SUBMIT IN TRIPLICATE - Other instructions on page 27. If Unit or CA/Agreement, Name and/or No.
891000303X1. Type of Well
☐ Oil Well ☒ Gas Well ☐ Other8. Well Name and No.
POKER LAKE-UNIT 27 BD 102H2. Name of Operator
XTO PERMIAN OPERATING LLC
Contact: KELLY KARDOS
E-Mail: kelly_kardos@xtoenergy.com9. API Well No.
30-015-46245-00-X13a. Address
6401 HOLIDAY HILL ROAD BLDG 5
MIDLAND, TX 797073b. Phone No. (include area code)
Ph: 432-620-437410. Field and Pool or Exploratory Area
PURPLE SAGE-WOLFCAMP (GAS)4. Location of Well (Footage, Sec., T., R., M., or Survey Description)
Sec 27 T25S R30E SWNW 2510FNL: 663FWL
32.101524 N Lat, 103.875427 W Lon.11. County or Parish, State
EDDY COUNTY, NM**12. CHECK THE APPROPRIATE BOX(ES) TO INDICATE NATURE OF NOTICE, REPORT, OR OTHER DATA**

XTO Permian Operating, LLC requests permission to make the following changes to the original APD:

Revisions to Operator-Submitted EC Data for Sundry Notice #497786

XTO Energy Inc.
Poker Lake Unit 27 Brushy Draw 102H
Projected TD: 26827' MD / 11099' TVD
SHL: 2510' FNL & 663' FWL, Section 27, T25S, R30E
BHL: 2440' FNL & 750' FWL, Section 10, T26S, R30E
Eddy County, NM

13-3/8" x 9-5/8" x 5-1/2" 10M RSH-2 Wellhead
Assembly, With T-EBS-F Tubing Head

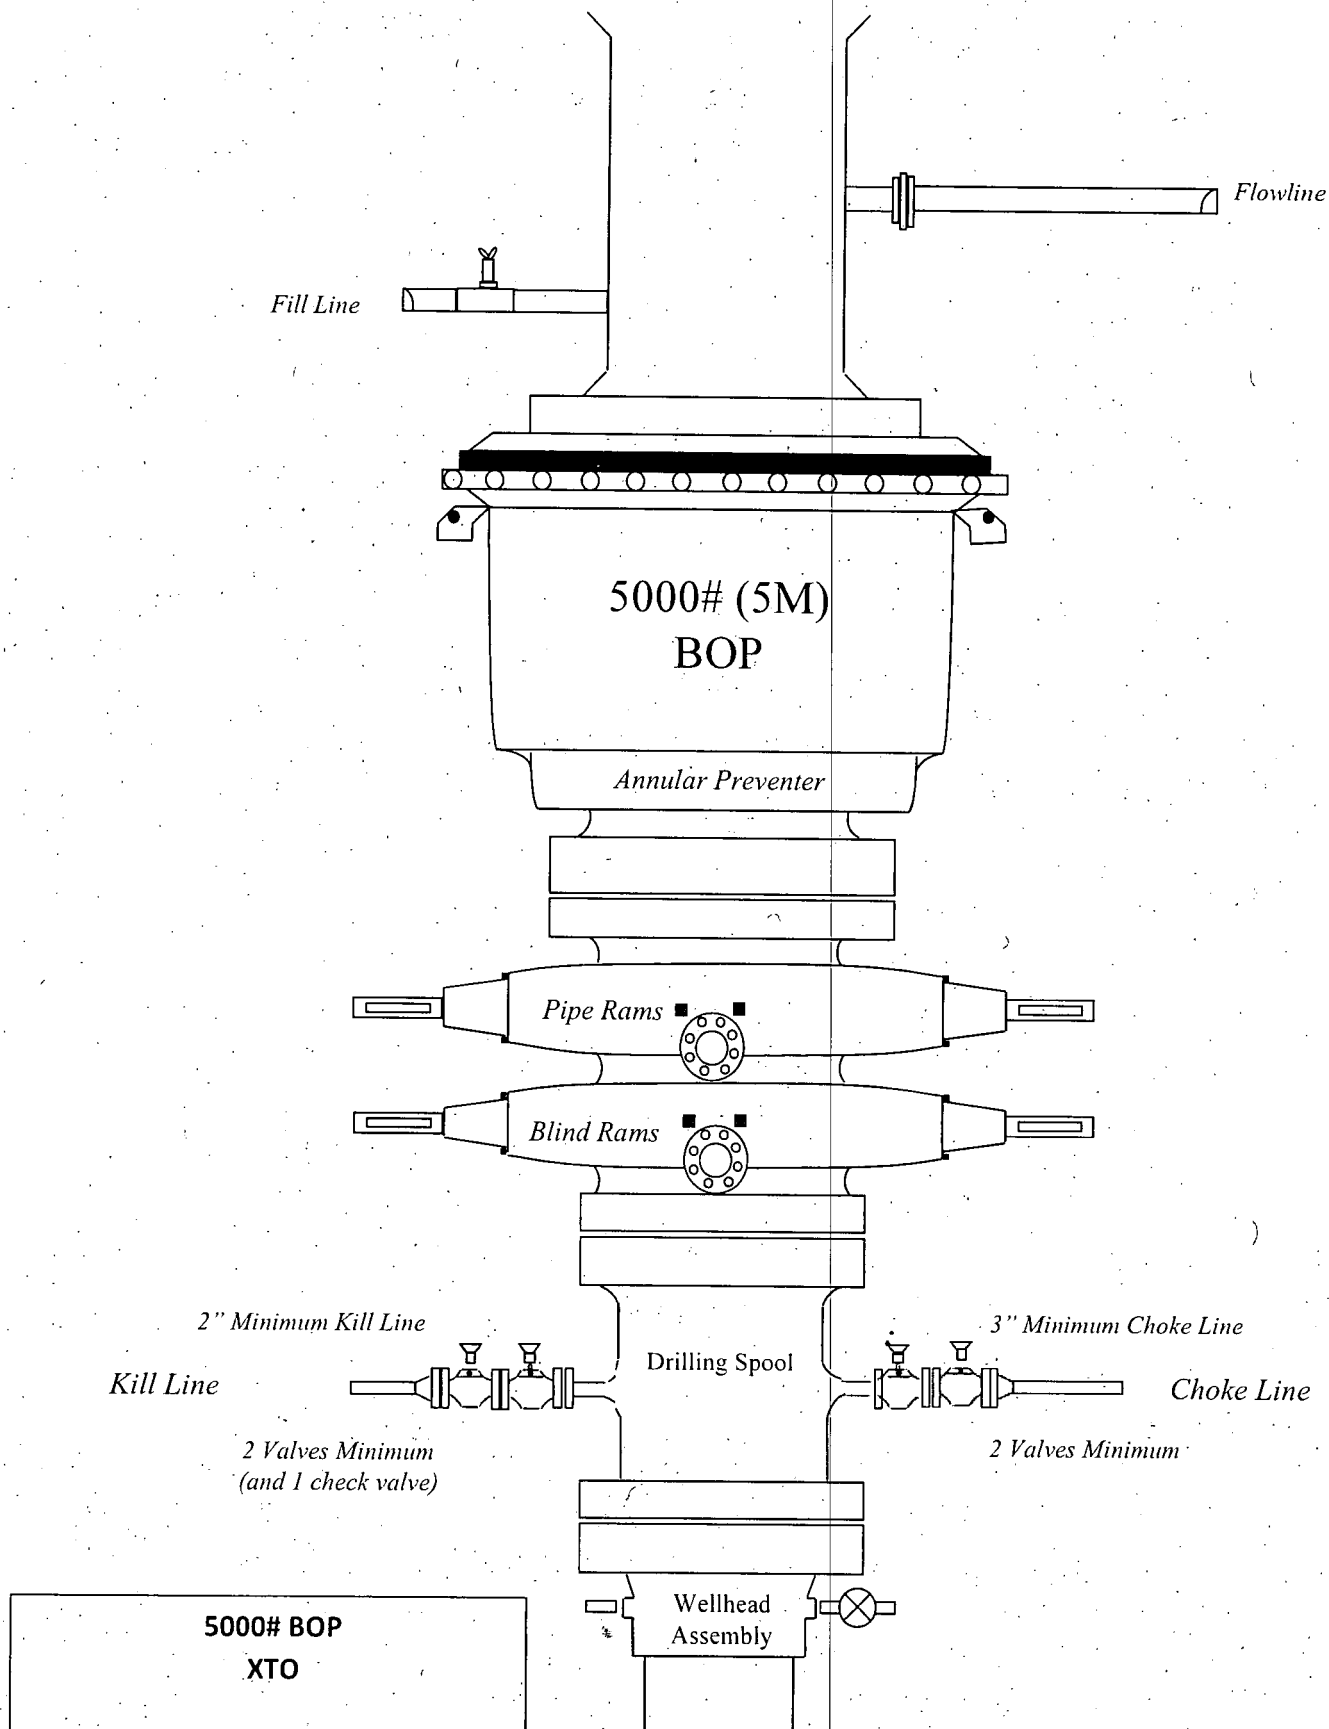
Permanent Wellhead - GE RSH Multibowl System

A. Starting Head: 13-5/8" 10M top flange x 13-3/8" SOW bottom

B. Tubing Head: 13-5/8" 10M bottom flange x 7-1/16" 15M top flange

Wellhead will be installed by manufacturer's representatives.

Manufacturer will monitor welding process to ensure appropriate temperature of seal.

Wellhead Manufacturer representative will not be present for BOP test plug installation

3. Operator has proposed a multi-bowl wellhead assembly. This assembly will only be tested when installed on the surface casing. Minimum working pressure of the blowout preventer (BOP) and related equipment (BOPE) required for drilling below the surface casing shoe shall be 5000 (5M) psi.

- a. Wellhead shall be installed by manufacturer's representatives, submit documentation with subsequent sundry.
 - b. If the welding is performed by a third party, the manufacturer's representative shall monitor the temperature to verify that it does not exceed the maximum temperature of the seal.

- c. Manufacturer representative shall install the test plug for the initial BOP test.
 - d. Operator shall perform the intermediate casing integrity test to 70% of the casing burst. This will test the multi-bowl seals.

5M Choke Manifold Diagram
XTO

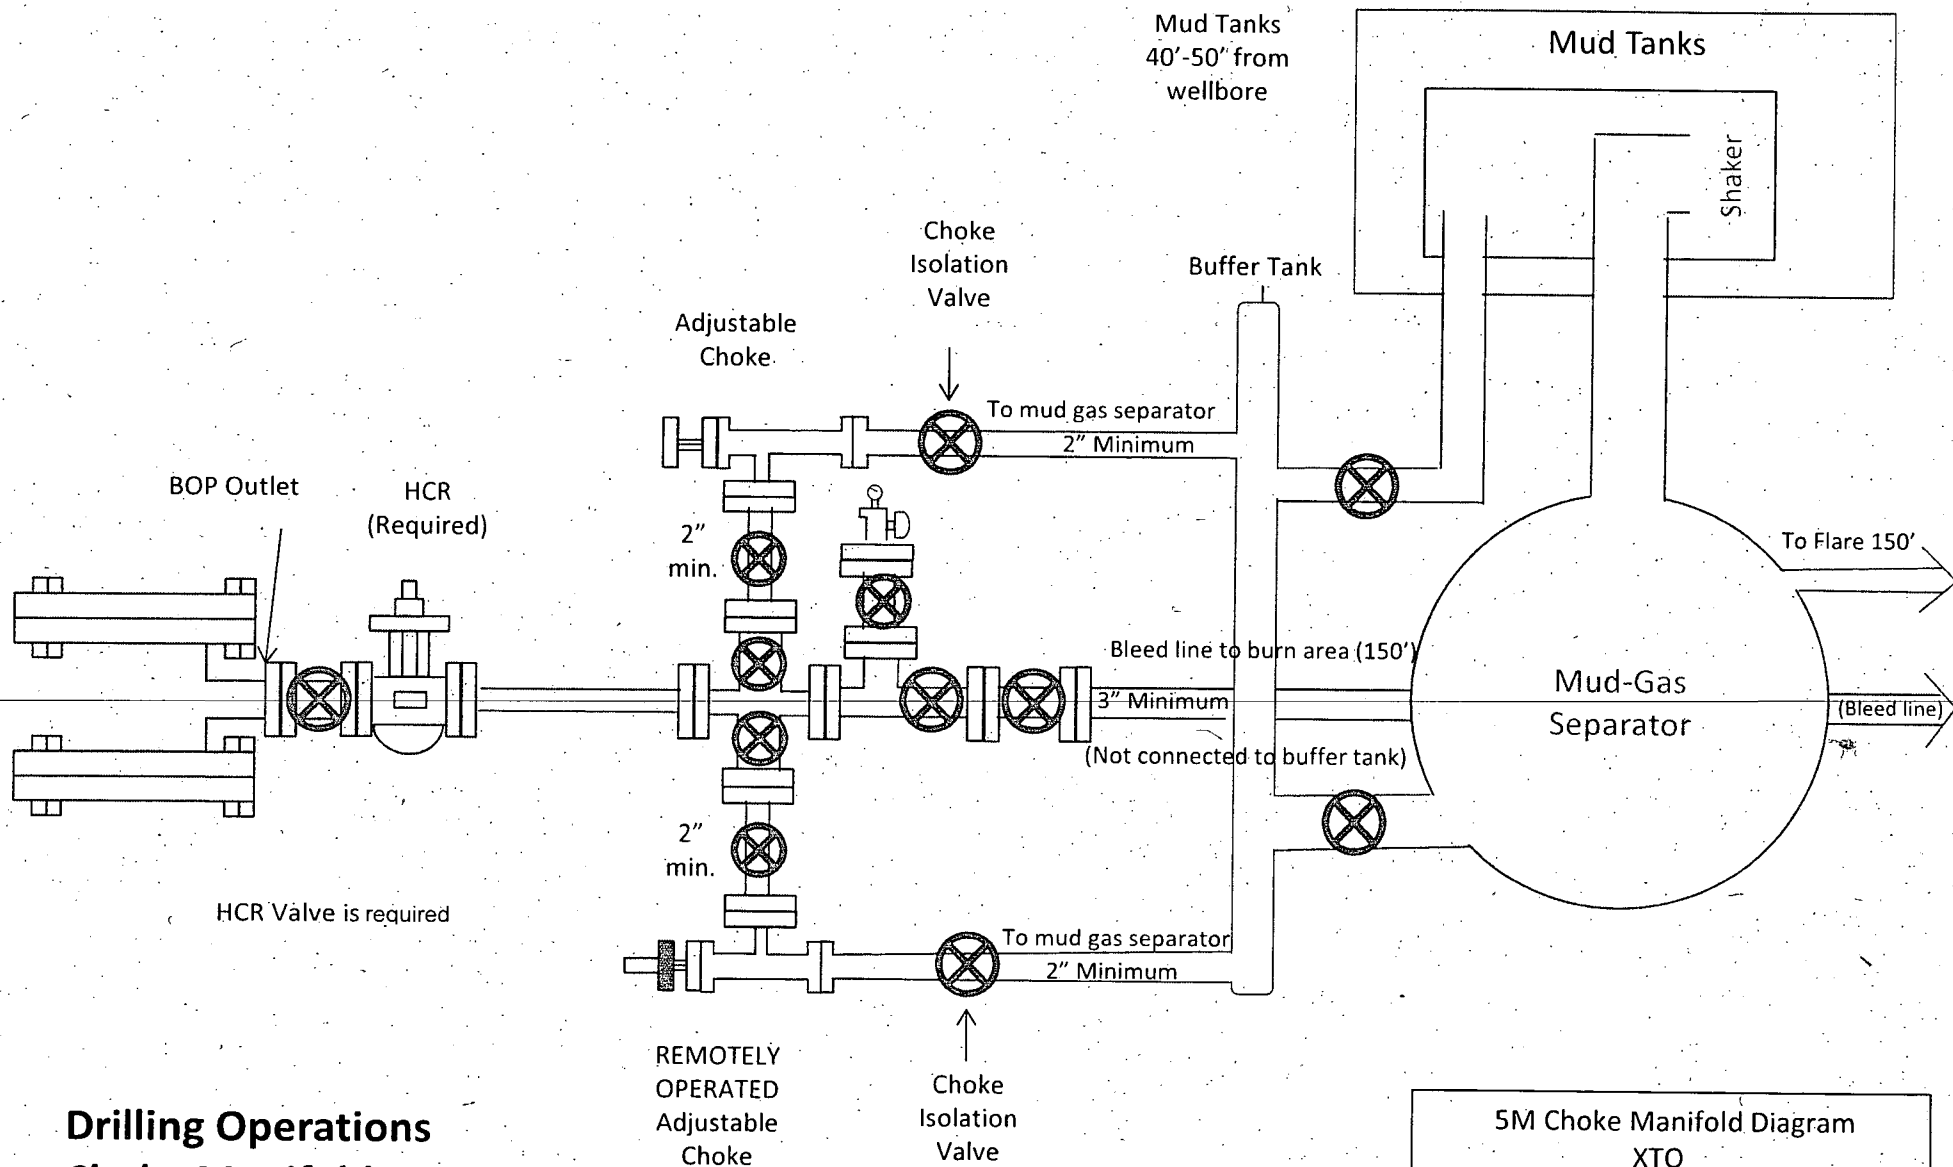
A variance is requested to allow use of a flex hose as the choke line from the BOP to the Choke Manifold. If this hose is used, a copy of the manufacturer's certification and pressure test chart will be kept on the rig. Attached is an example of a certification and pressure test chart. The manufacturer does not require anchors.

2. Variance approved to use flex line from BOP to choke manifold. Check condition of flexible line from BOP to choke manifold, replace if exterior is damaged or if line fails test. Line to be as straight as possible with no hard bends and is to be anchored according to Manufacturer's requirements. The flexible hose can be exchanged with a hose of equal size and equal or greater pressure rating. **Anchor requirements, specification sheet and hydrostatic pressure test certification matching the hose in service, to be onsite for review. These documents shall be posted in the company man's trailer and on the rig floor.** If the BLM inspector questions the straightness of the hose, a BLM engineer will be contacted and will review in the field or via picture supplied by inspector to determine if changes are required (operator shall expect delays if this occurs).
